ADDENDUM NO. 001

Architects Project No.: 23042

Project Name: Ralston Apartment Renovations

PLANS AND EXTERIOR ELEVATIONS

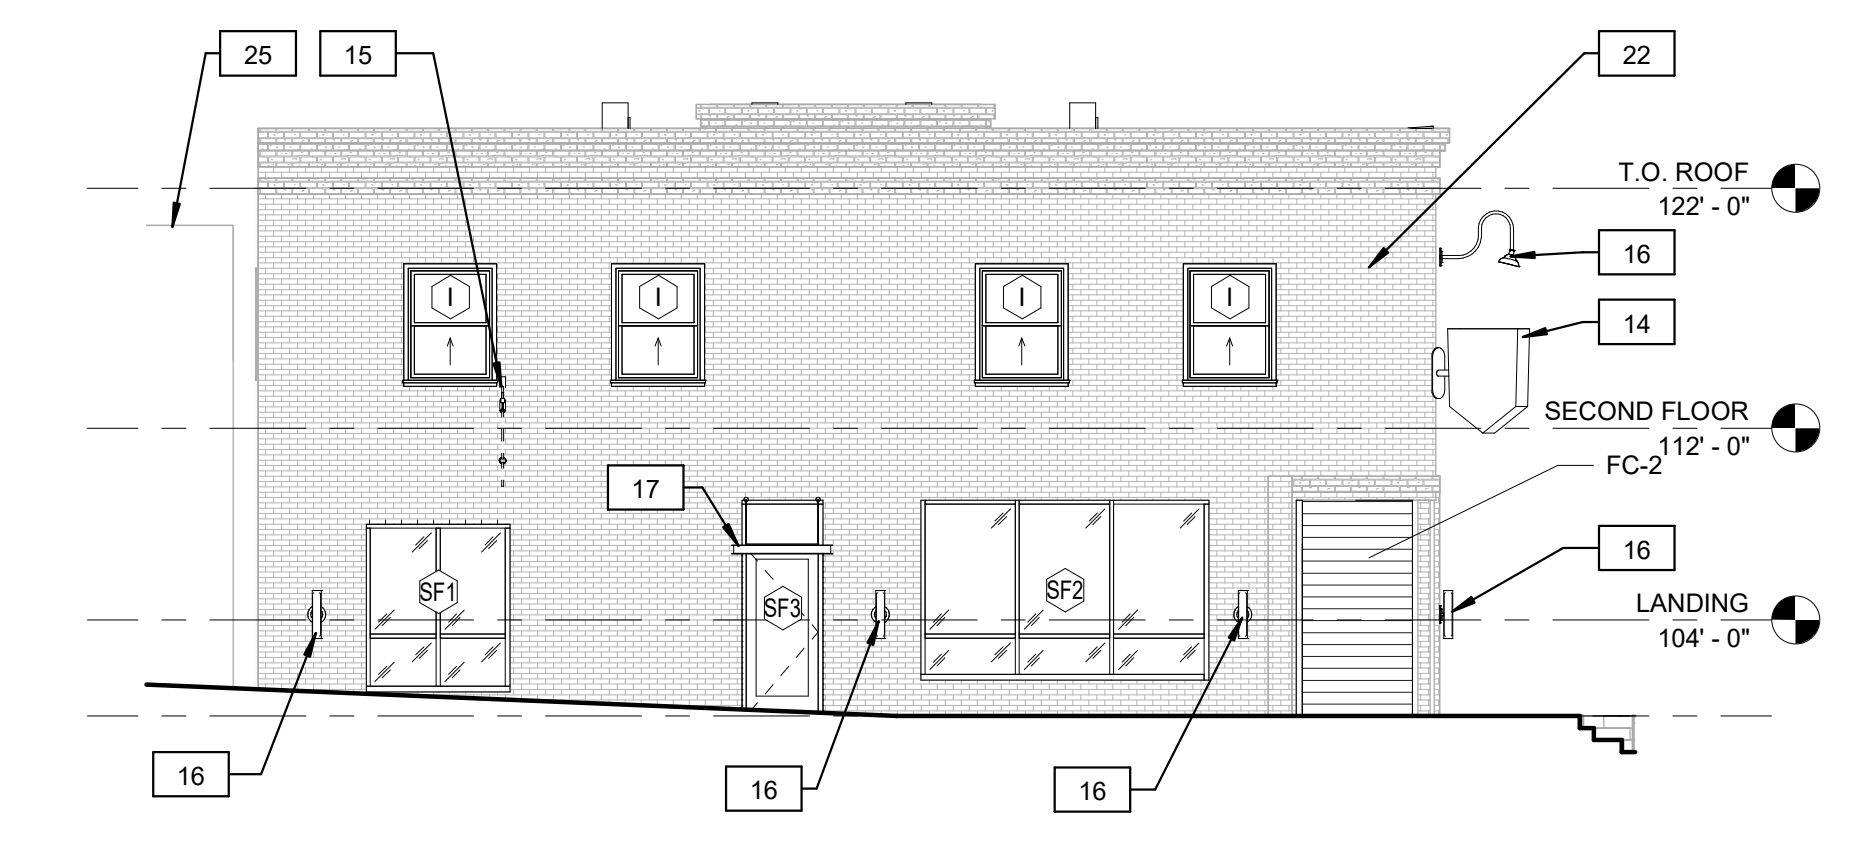
1. Is the roof being fully replaced? Please provide a roof spec if so.
 - a. Per keynote 27 on sheet A301, intention is to match and cricket into the existing roof.

5. Sheet - A301 PLANS AND EXTERIOR ELEVATIONS
 - a. Identified colors in finish legend for exterior finishes.
6. Sheet - A501 CASEWORK DETAILS
 - a. Added counter edge dimension to SSM material
